THE NAPA COUNTY REGIONAL PARK AND OPEN SPACE DISTRICT
Camp Berryessa Improvement Project

ADDENDUM Nº 4

Issued: October 14, 2014

Scale NONE
 Drawing No. G00.08
 Sheet No. 8 of 70

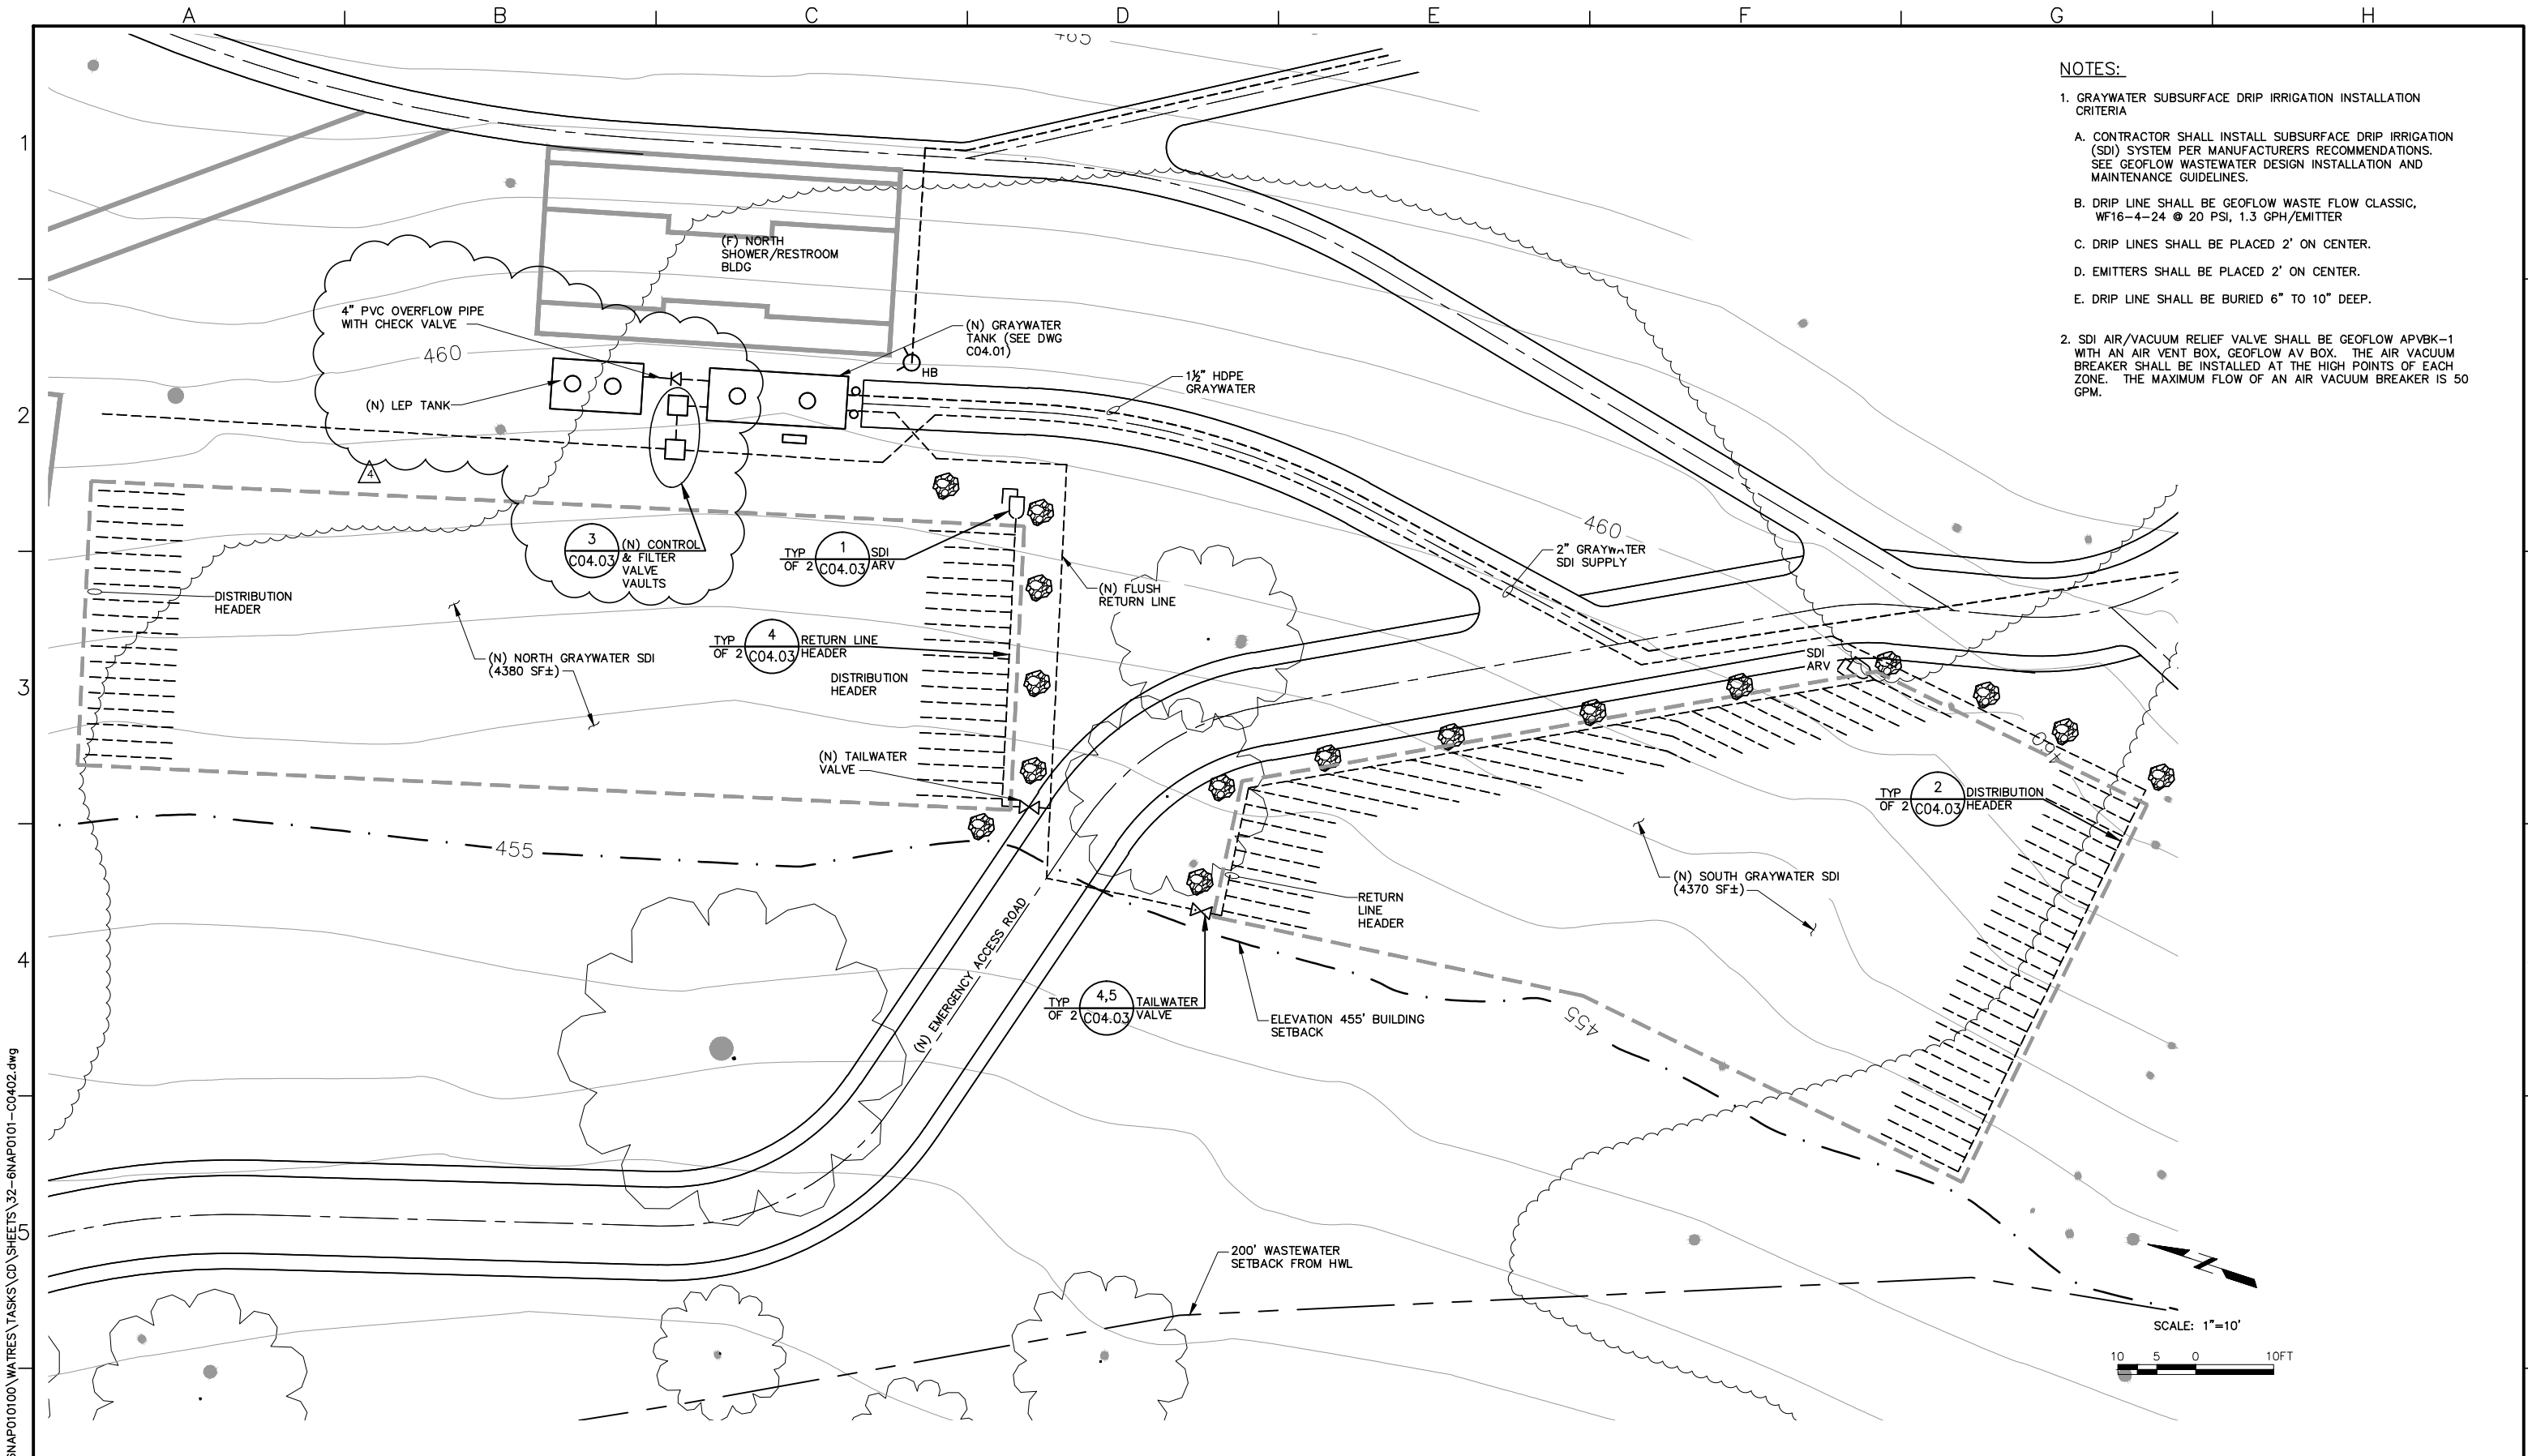
5. Question: Section 11121 Grey Water System / 1.04 / A calls for two fiberglass single compartment 1,500 gallon tanks. This is in conflict with drawing G00.08 that call for one 2,500 gallon and one 1,200 gallon tank. This tank material specified in section 11121 / 1.04 / A is also in conflict with section 11121 / 1.05 / A / 3 which calls for concrete tanks. Please clarify tank size and material.

Answer: The tanks can be concrete or fiberglass per G00.08, and are to be the capacities listed on drawing G00.08. There is one 2500 gallon tank and one 1500 gallon min capacity tank at the future north combo building, and one 1200 gallon min capacity and one 1500 gallon min capacity tanks at the south combo building. Four tanks total, this project (previously 3 – the fourth is a change for this addendum).

Scale AS NOTED
 Drawing No. C04.02
 Sheet No. 32 of 70

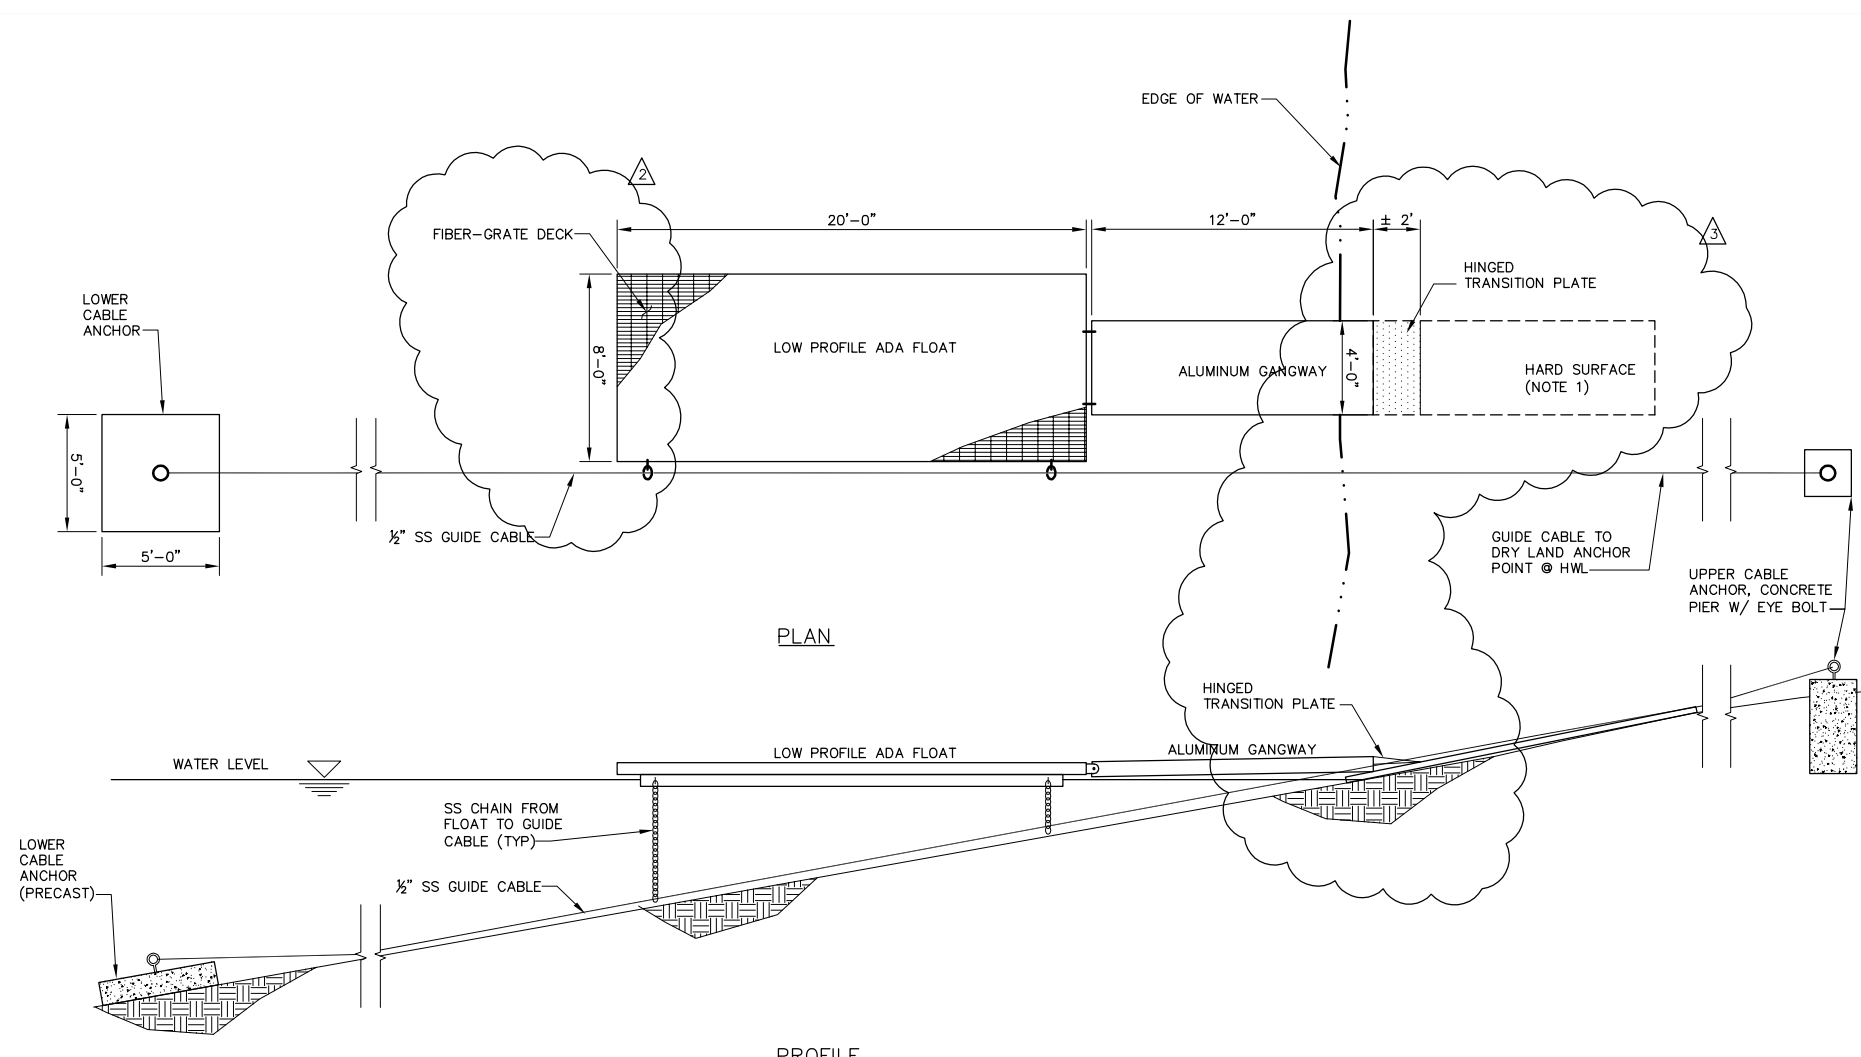
1. Revised sheets G00.08, C04.02, C11.02 included in this addendum
2. Question: Drawing C06.01 only shows roofing on half of the building but there is no note that this is only for clarity. Does entire structure get roof or only half?.
